Clark County Health Department

Re: Site Survey #2025114
 Parcel #10-13-01-200-065.000-035
 Carter Place, Borden, In

APPROVAL

SEPTIC SYSTEM LAYOUT PLAN

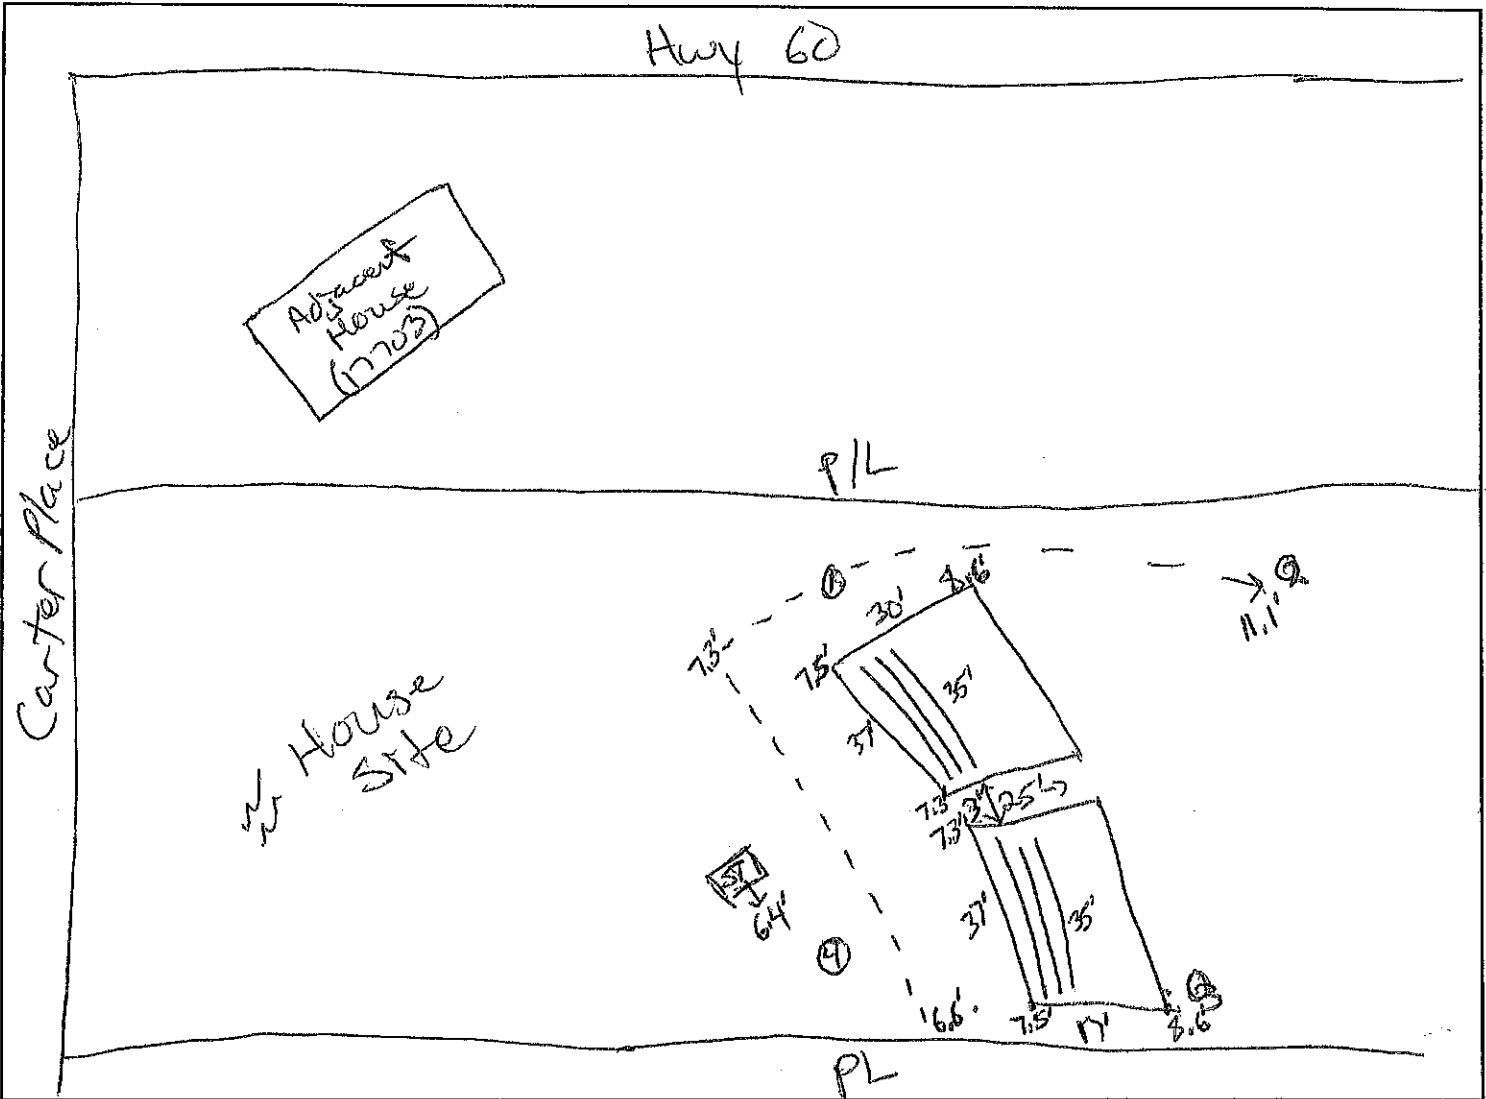
COMMENTS: 12" in. soil cover, 35" in. Interceptor drain, 6" in. Sand depth, in. Perimeter drain, Swale

* SLS subsurface is split bed only on elev. SLS, same for 12" sand under pipes.

Note: Site meets minimal standards for install.
